PARTS & SERVICE NEWS

REF NO.	AA00173
DATE	31, October 2000

- SUBJECT:** RADIATOR SIGHT GAUGE REWORK & RADIATOR FILLING PROCEDURE
- PURPOSE:** To introduce proper radiator filling instructions for all electric drive trucks and radiator rework instructions for certain 830E & 930E trucks
- APPLICATION:** 445E: AFE39-A & up; 445E: AFE41-A & up; 510E: AFE40-A & up; 510E: AFE44-A & up; 630E: AFE42-A & up; 630E: AFE46-A & up; 730E: AFE47-A & up; 730E: A30079 & up; 830E: AFE32-A & up; 830E: AFE50-A & up; 830E: A30544 & up; 930E: AFE48-A & up; 930E: A30019 & up.
- FAILURE CODE** 032316
- DESCRIPTION:** To ensure proper radiator filling procedures for all electric drive dump trucks listed above and to correct coolant level sight gauges on certain 830E & 930E dump trucks.

FIGURE 1. 830E RADIATOR

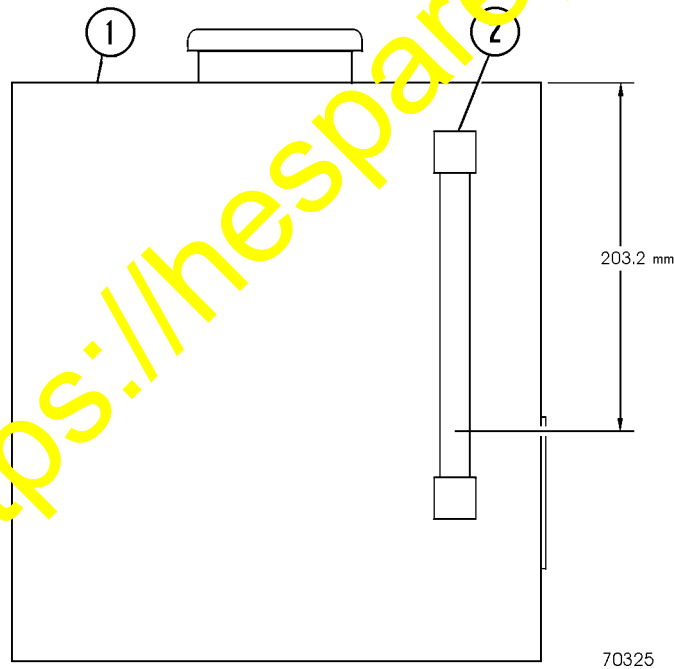
On 830E trucks (serial number suffix AFE32-A through AFE32-FA and AFE50-A through AFE50-W), the sight gauge should be modified so the proper radiator filling height will be correct when filled using the procedure above. Refer to page 2 (Figure 1) for rework instructions.

Reference drawing EJ2255 is used to rework sight gauge, or follow instructions below.

1. Clean sight gauge of oil, grease or antifreeze.
2. Measure and mark at dimension shown in Figure 1.
3. Mask upper portion of sight gauge with masking tape.
4. Paint lower portion of sight gauge with black paint.
5. Remove masking tape.
6. Ensure that coolant level is visible in sight gauge.

FIGURE 2. 930E RADIATOR

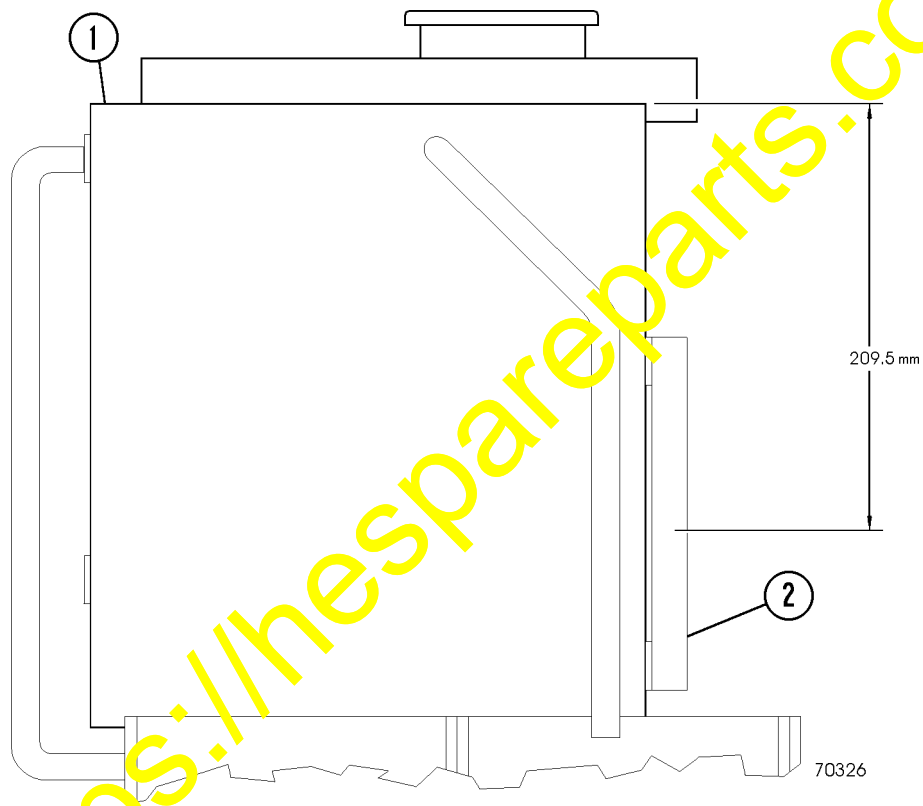
On 930E trucks (serial number suffix AFE48-A through AFE48-BK), the sight gauge should be modified so the proper radiator filling height will be correct when filled using the procedure given above. Refer to page 3 (Figure 2) for rework instructions.

Reference drawing EJ2256 is used to rework sight gauge, or follow instructions below.

1. Clean sight gauge of oil, grease or antifreeze.
2. Measure and mark at dimension shown in Figure 2.
3. Mask upper portion of sight gauge with masking tape.
4. Paint lower portion of sight gauge with black paint.
5. Remove masking tape.
6. Ensure that coolant level is visible in sight gauge.
